Application no: 22/03078/FUL

Location: Land Bounded by Meadow Lane and Church Way, Iffley, Oxford

Construction Traffic Impact Assessment

Figure 6: Five-day average flow Profile – Meadows Lane

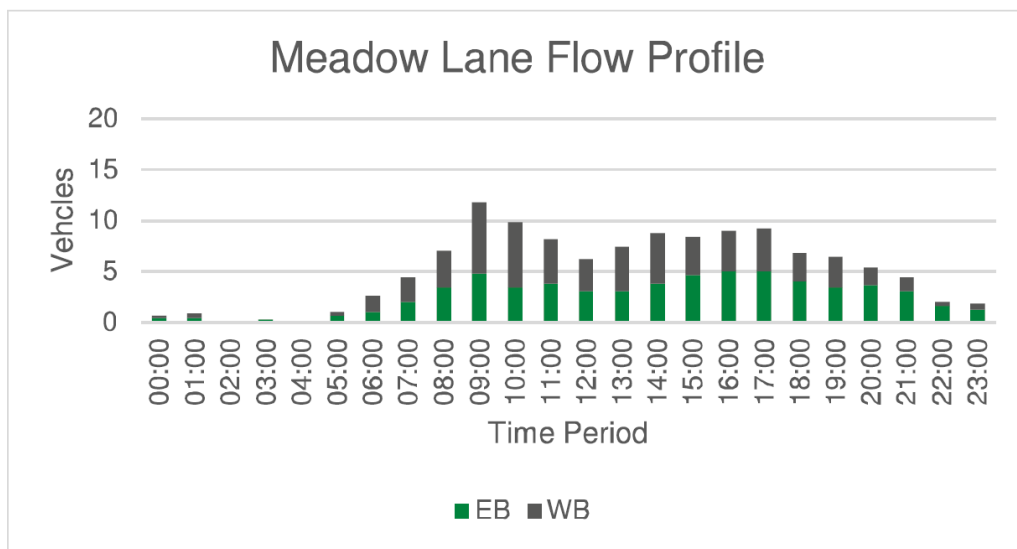
- 7.1** The applicant's Traffic Statement solely analyses traffic movements generated by the completed development. The conclusions are detailed in the tables below.
- 7.2** The Meadow Lane Flow profile indicates a vehicle trip generation of 12 movements between 08.00 and 09.00 which will be the time for peak construction vehicle movements.
- 7.3** Our analysis above shows construction movements during this period will be generally c.2.5x higher (32), with a peak significantly higher and this is exclusive of delivery vehicles entering the site at this time.

- 7.4** Afternoon peak construction vehicle movements are between 15.30 and 16.30 and our analysis above shows these movements to also be generally 32. By contrast, the applicant’s assessment of Meadow Lane flow profile shows the completed development generates 7-8 movements in this time window.

- 7.5** So during the 15 month construction period traffic flows on the Iffley road network will be between 3-5 times greater than that generated by the completed development.
